PRODUCT CHANGE NOTICE PCN Form (D4-E000-73)

PCN#17-076

**ROS-1750W-619+
ZX95-1750W-S+**

1. Replacement of supplied transistor and varactor diode based on discontinuation of supply with alternate, qualified components.
2. Change of internal component values to optimize replacement parts

ZX95-1750W+

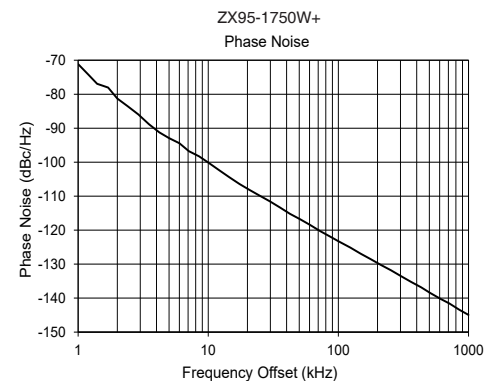
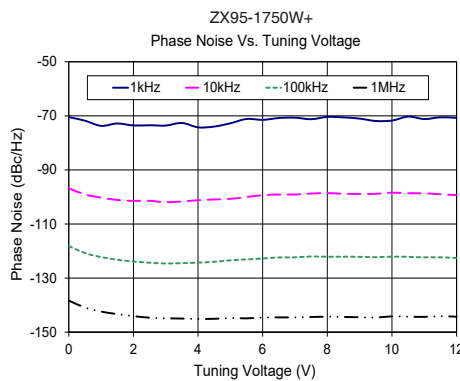
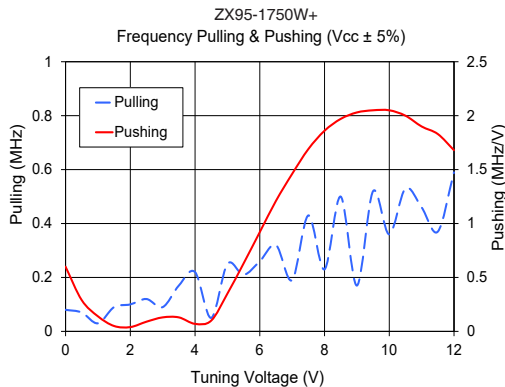
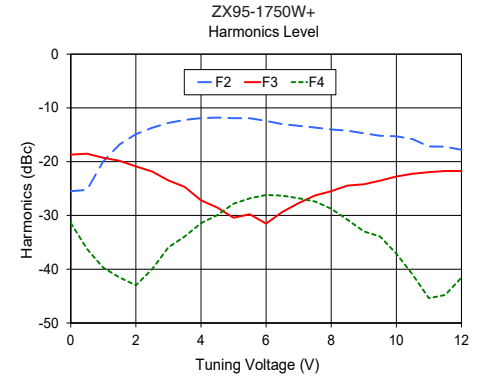
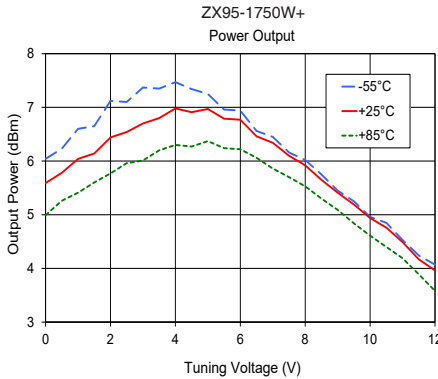
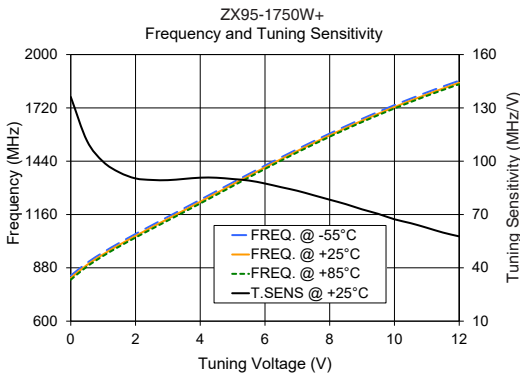
Shift in performance and changes in specification per table below:

Parameters	Original Performance	Original spec	New Performance	New Spec
DC Current	24.4 to 24.8 mA	35 mA Max	30.2 to 31.9 mA	37 mA Max
2 nd Harmonic	-23.56 to -17.08 dBc	-20 dBc Typ -10 dBc Max	-26.43 to -12.13 dBc	-14 dBc Typ

See Updated datasheets below for change in performance, once stock of old assembly is depleted datasheets will be updated and available via the model dashboard.
